REV.
C

SAE AS1583

FITTING, TEE, INTEGRAL
WELD RING, 3000 PSI

FIGURE 1 - FITTING, TEE

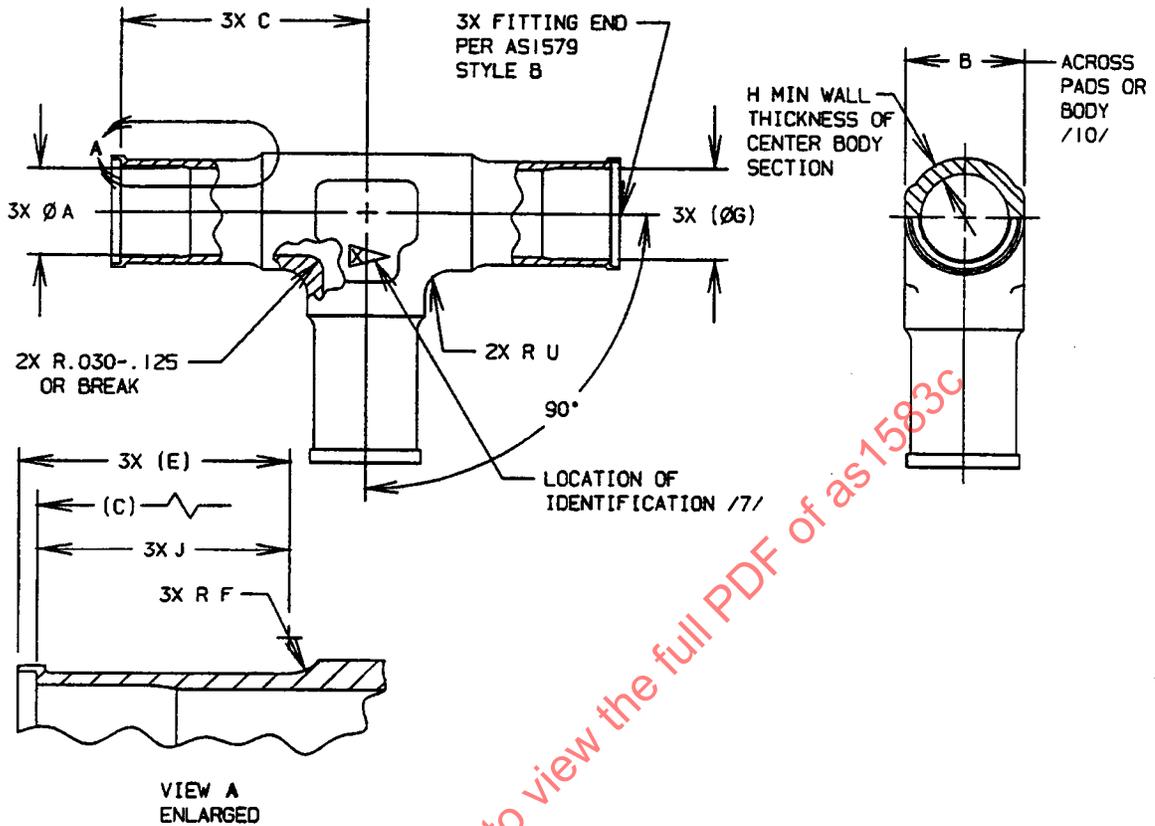
9. DIMENSION "J" HAS BEEN ADDED TO THIS REVISION TO REPLACE DIMENSION "E" TO RELATE THE TURN LENGTH TO THE TUBE STOP. THE NOMINAL DIMENSION OF "E" HAS NOT CHANGED AND IS SHOWN AS A REFERENCE. IT MAY BE DELETED AT THE NEXT REVISION.
